FINAL Environmental Impact Statement

U District Urban Design Alternatives

City of Seattle
Department of Planning & Development

January 8, 2015

Figure 3.9-6:
Electric Network Service Area Underground Electric Service Area

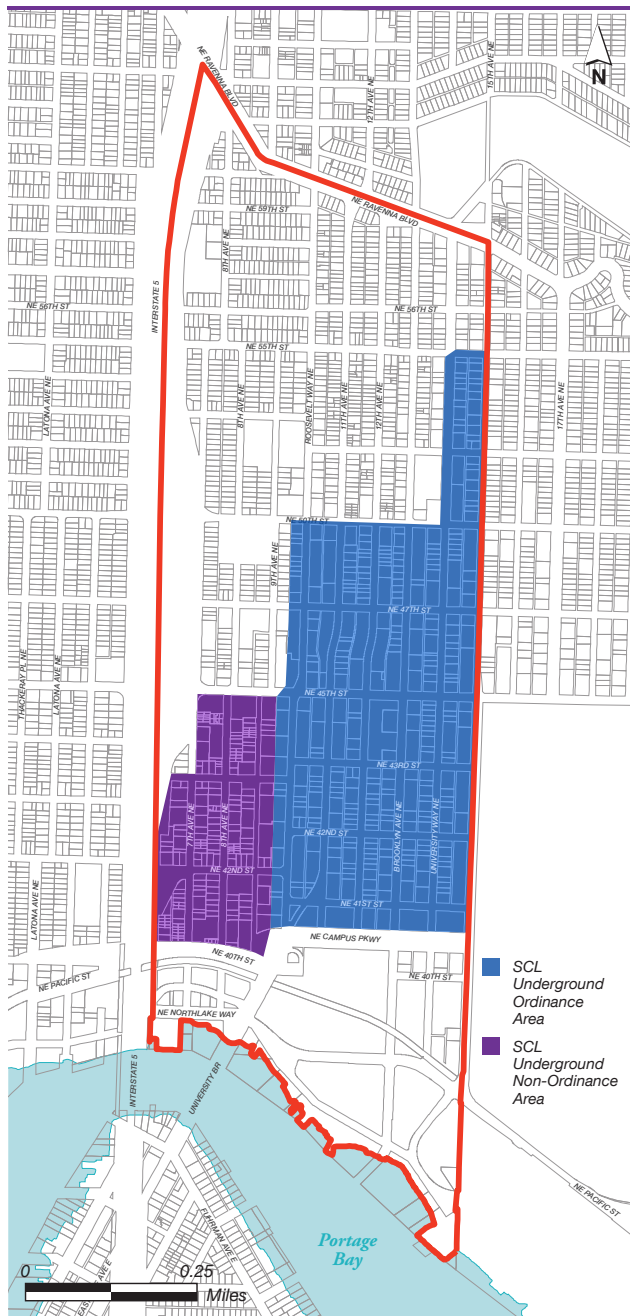
Page 3.9-6. Figures 3.9-6 and 3.9-7 are corrected as shown below.

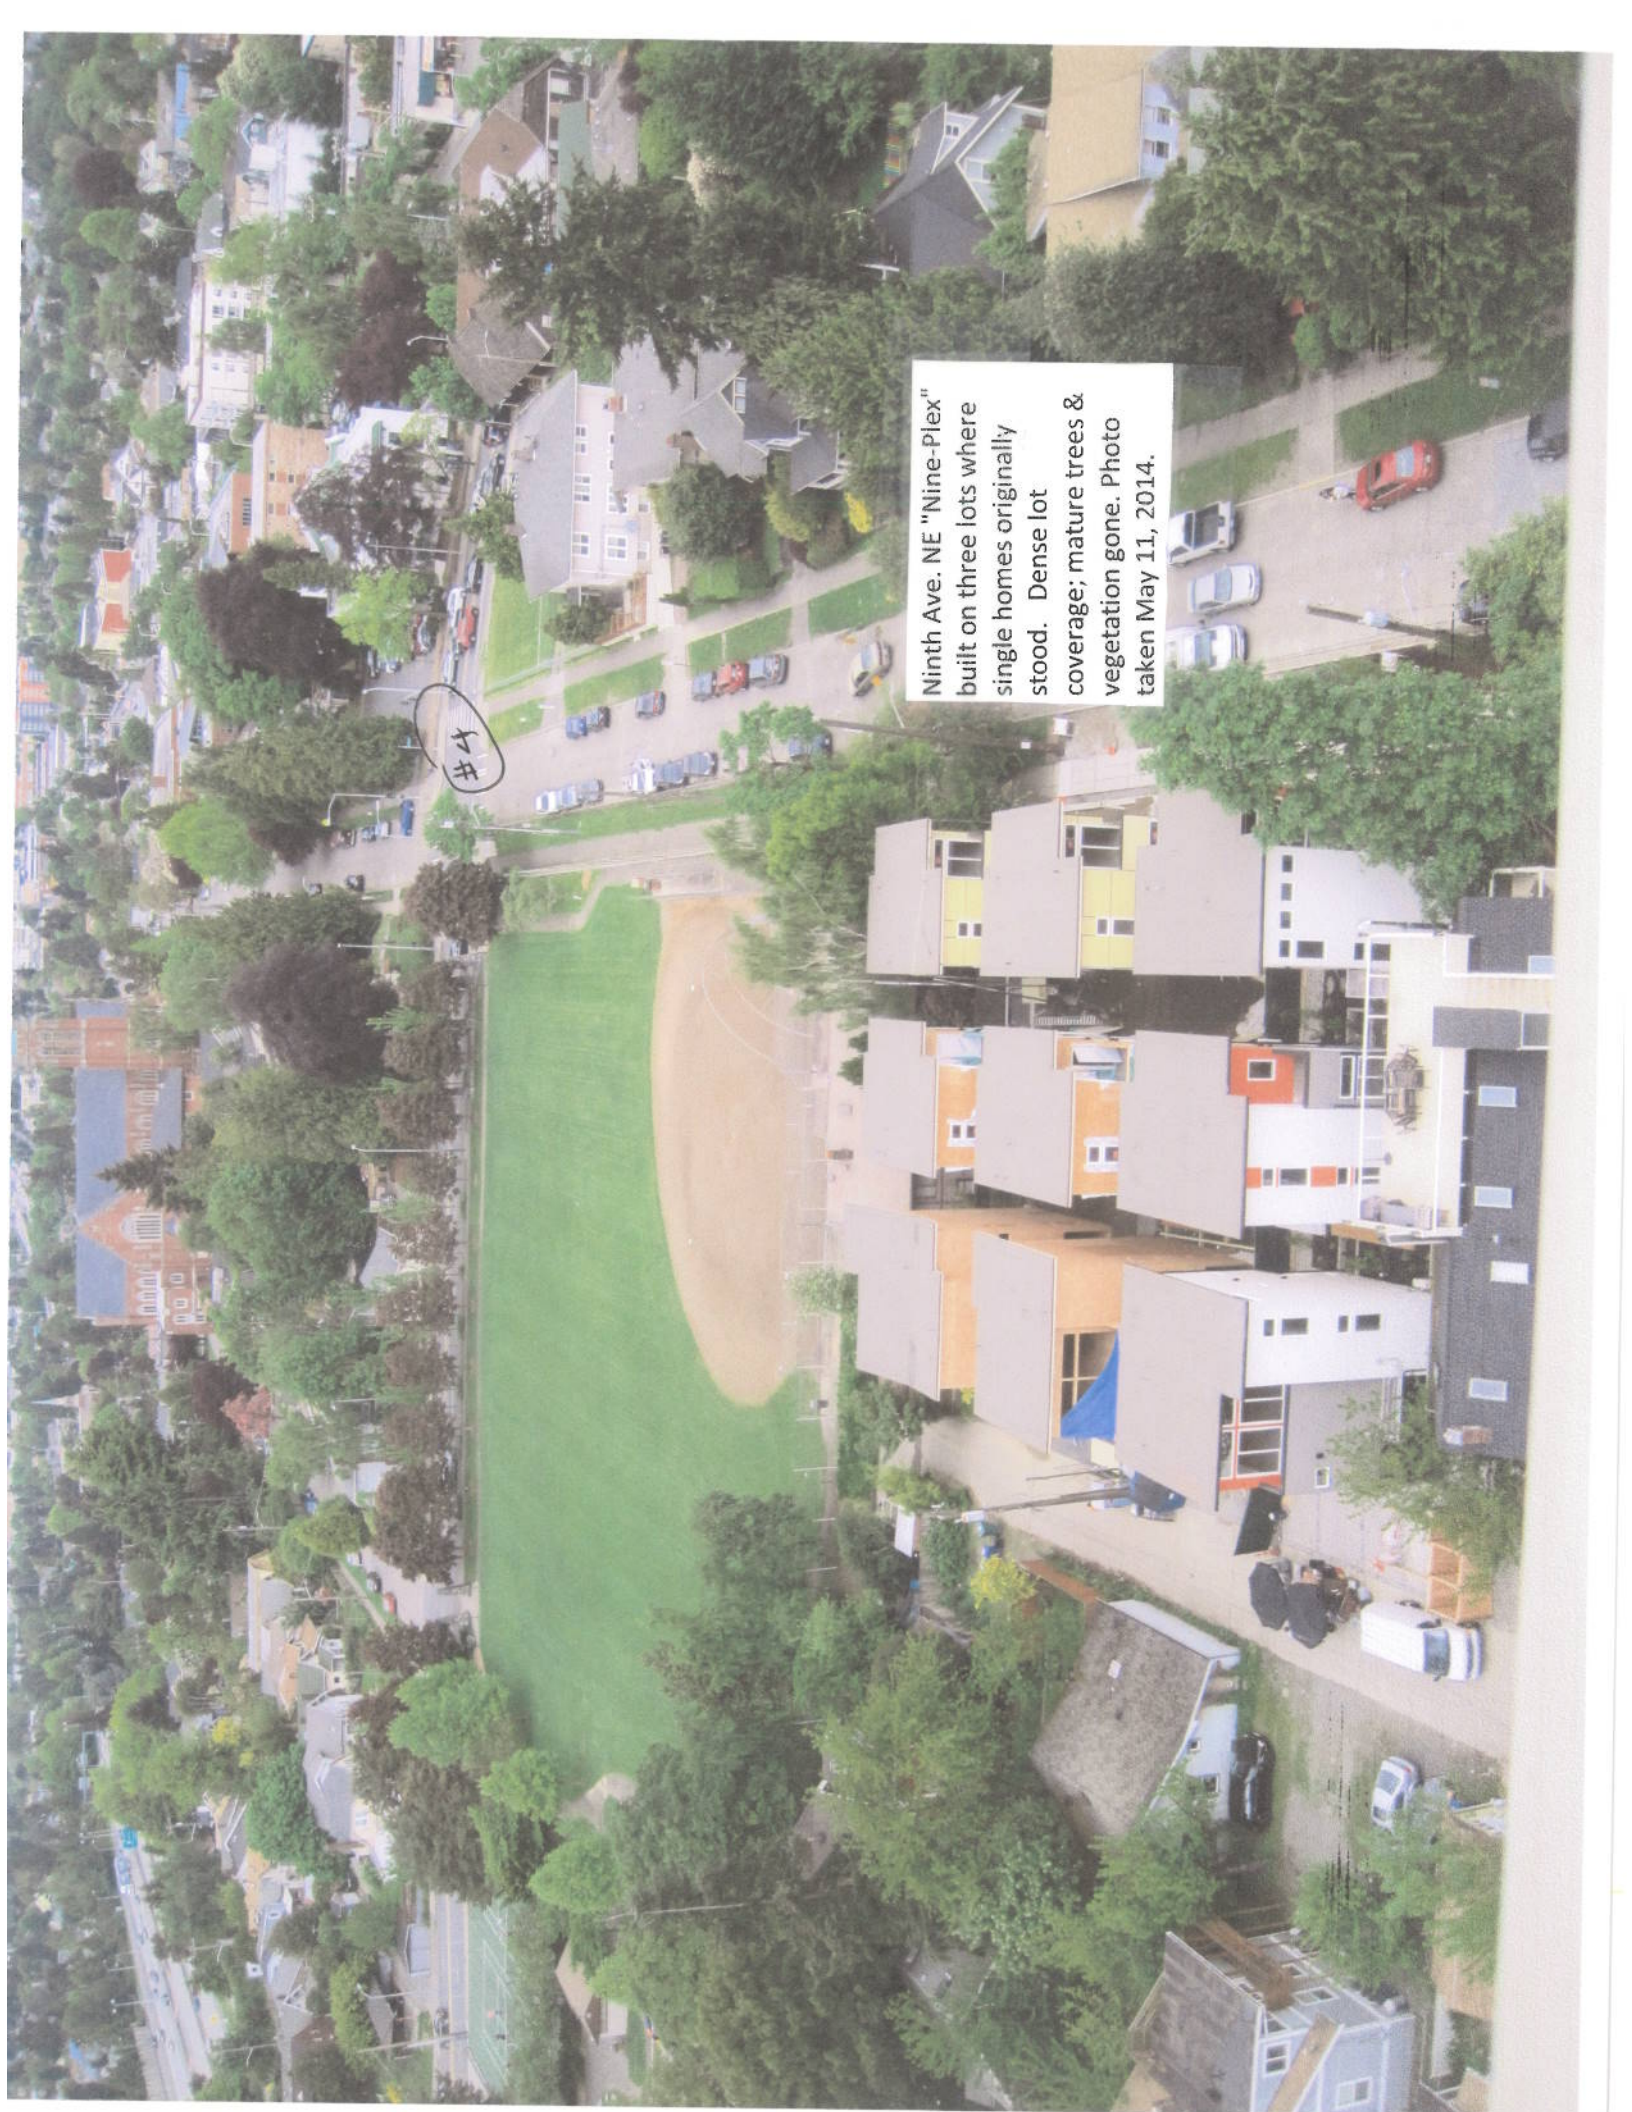
- 5 4. Photo taken May 11, 2014 of the same area as Photo 3 (Ninth Ave. NE between 47th St. NE & the Playfield). It shows the aesthetic damage done to a neighborhood when developers are allowed to remove mature vegetation and yard space and build up against sidewalks and alleys with minimal set-backs. Code and programmatic changes are needed to require or incentivize set-backs and reduce the bulk and lot coverage allowed for new structures. These measures should not be tied to "affordable housing" goals, as appears in all DEIS alternatives. But rather, the bulk, lot coverage, and open space regulations should be tied to mitigating the adverse environmental impacts to the neighborhoods and present and future residents.
